Product Change Notification (PCN)

Date: 02.04.2020
No.: T-1436

Narrow Pitch Connectors P5K, P5KS, P5KF and P4

Notification change of embossed tape specification.

Changes to embossed tape specifications

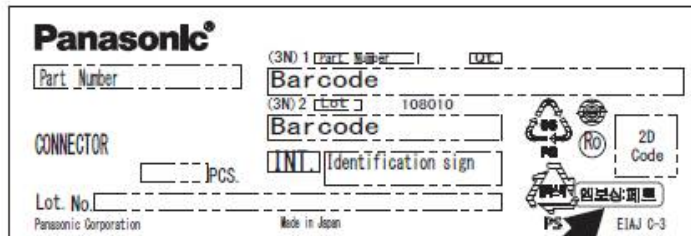
Before change	After change
P5K	Material	PET	PS
	Thickness	0.40 mm	0.30 mm
P5KS	Material	PET	PS
P5KF	Material	PET	PS
P4	Material	PET or PS	PS

*Thickness will also change for P5K.

*There is a partial change to the pocket shape. However, there is no change to the pilot hole or pitch dimension between products.

■ Changes to label

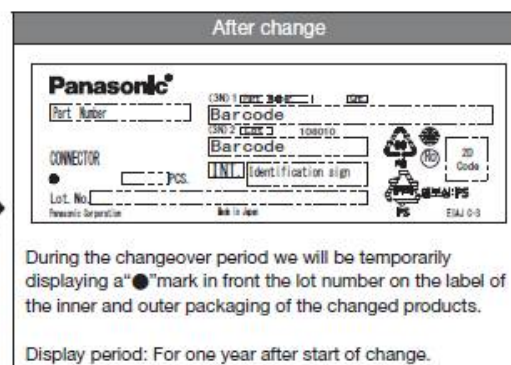
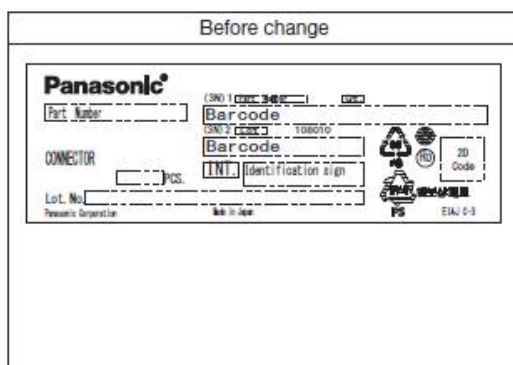
After changing the embossing material, the Korean packaging recycle mark on the inner packaging label will change.

(There will be no change to the outer packaging label.)

Before change

엠보싱:페트 Embossed: PET

After change

엠보싱:PS Embossed: PS
